**NOTICE OF A REGULAR MEETING
BONDURANT PLANNING AND ZONING COMMISSION
NOVEMBER 9, 2023**

TITLE: Resolution considering recommended approval of Dollar Tree First Addition Final Plat.

TITLE: Resolution considering recommended approval of Dollar Tree Site Plan.

TITLE: Resolution considering recommended approval of Campus Industrial Park Preliminary Plat.

1. Dollar Tree First Addition Plat
2. RES. NO. PZ-231109-35

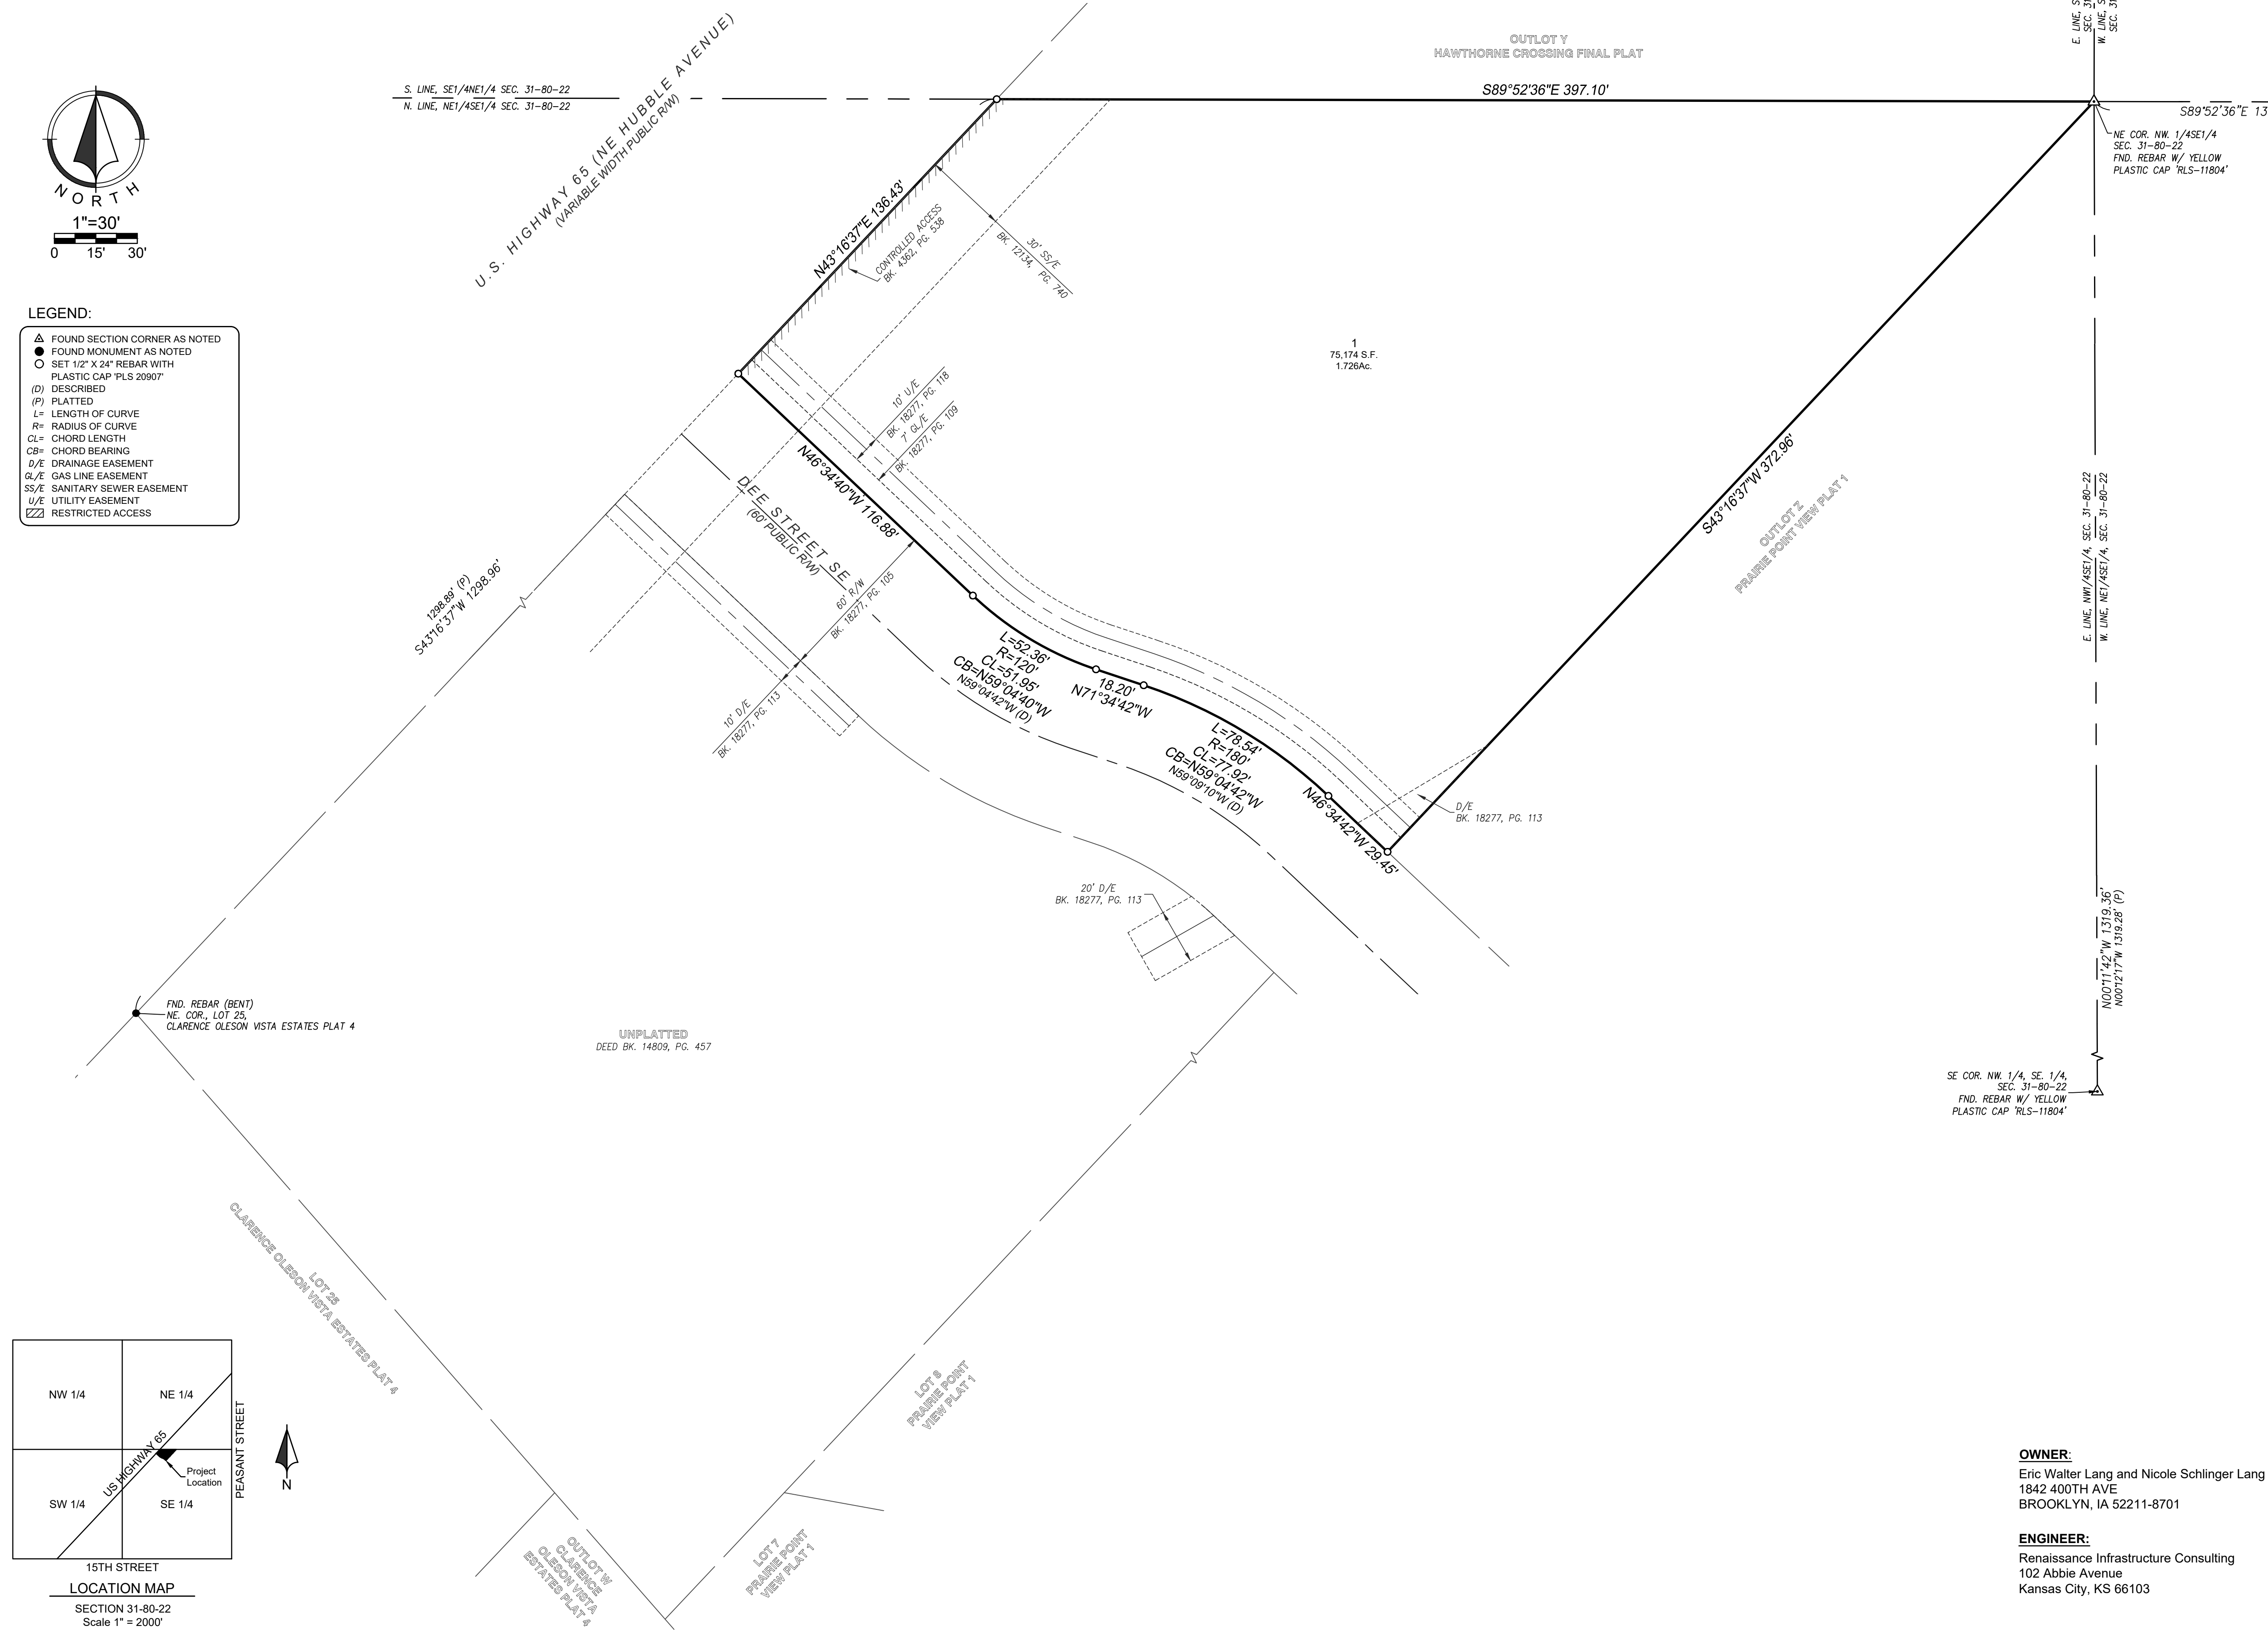
Pedestrian Connections – the final plat does not show pedestrian connections along Dee Street SE. The submitted site plan for the proposed Dollar Tree does show sidewalk to be installed along Dee Street SE.

Sheet
C0.0

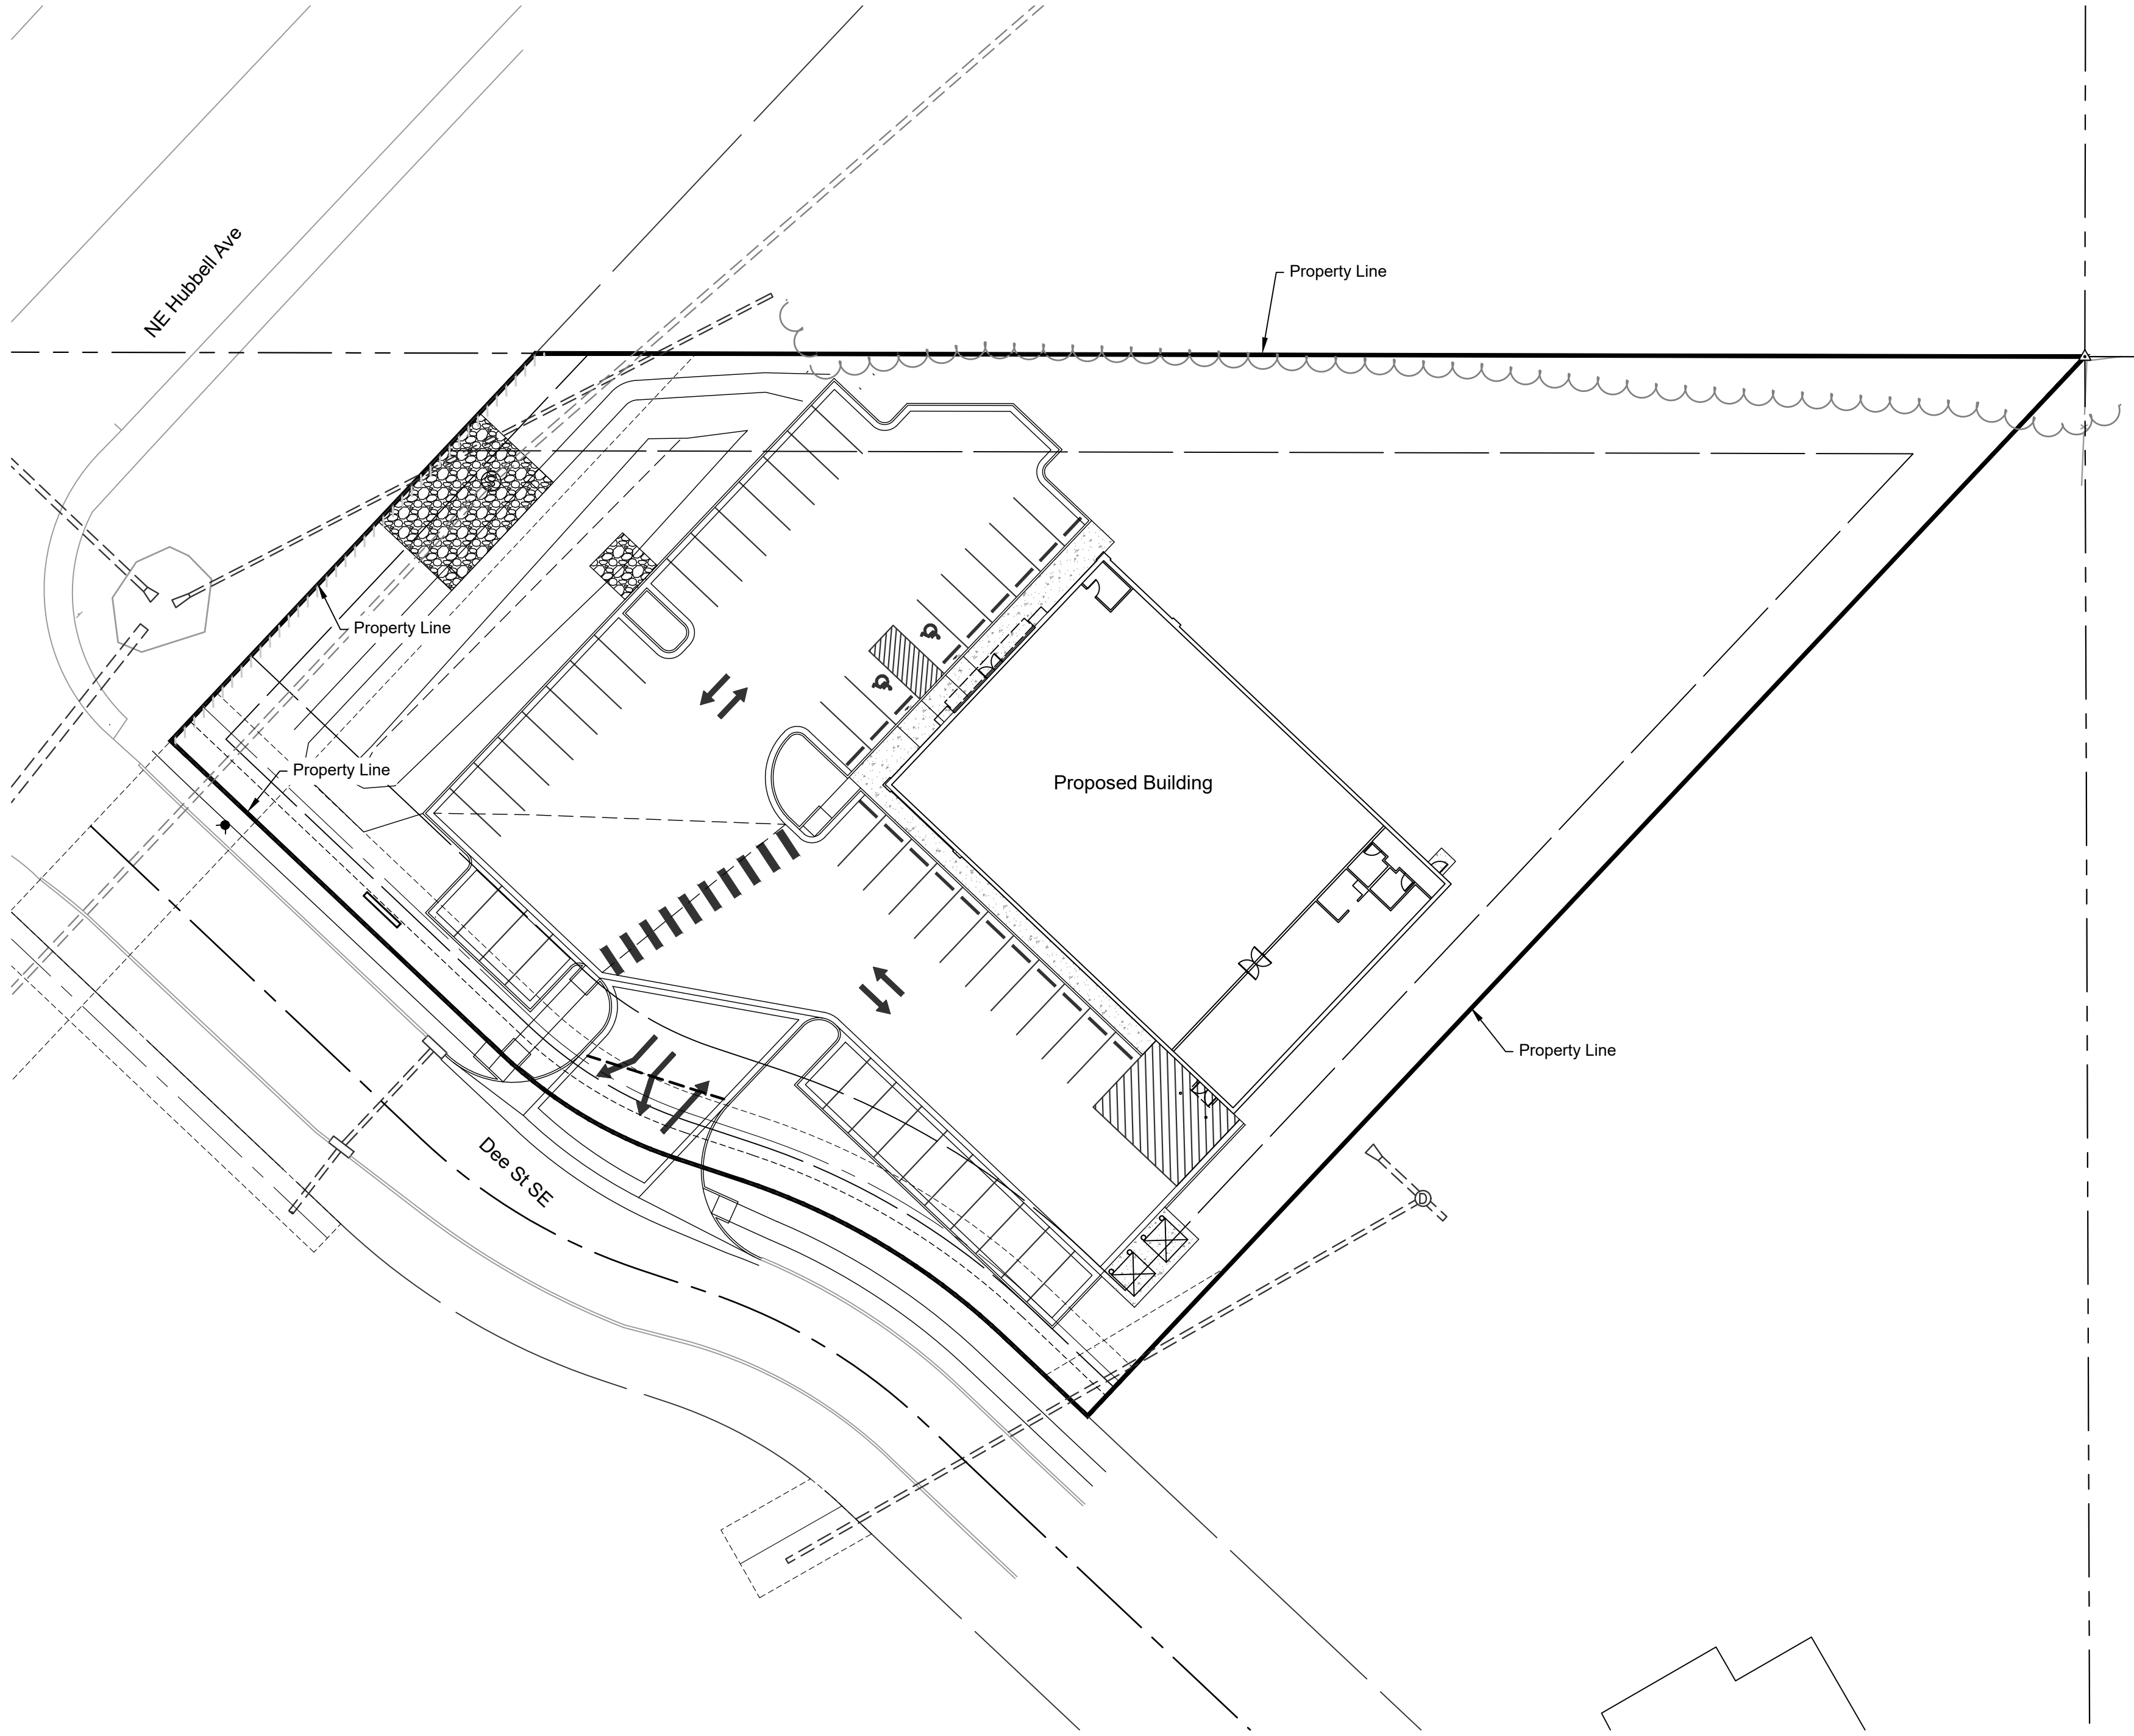
- The site plan labels the required setbacks at this location - a 30' front yard setback along Dee Street SE and the northwest property line fronting Hubbell Avenue, a 25' rear yard setback from their northeastern property line and no side yard setback from southeasterly property line.

- Access to the site is available from Dee Street SE.
- The site plan shows that no part of any parking/drive area (excluding driveways) will be located closer than 10' away from the front property lines, as is required by Section 177.10.1.

- The site plan shows 50 parking spaces, including 2 handicap stalls, and 1 loading spaces.
- The site plan shows parking spaces will be provided with raised curbing or equivalent, as is required by Section 177.10.8.

- Staff has determined this development will require a traffic impact study to be completed. It is anticipated the traffic impact study will determine whether a deacceleration lane on Hubbell Avenue will be required. The developer has been in contact with Veenstra & Kim to complete this study. Any findings from the traffic impact study that require alterations to the site plan will be reviewed by staff. If major alterations to the site plan are required, staff will submit the site plan for additional review by the Commission.
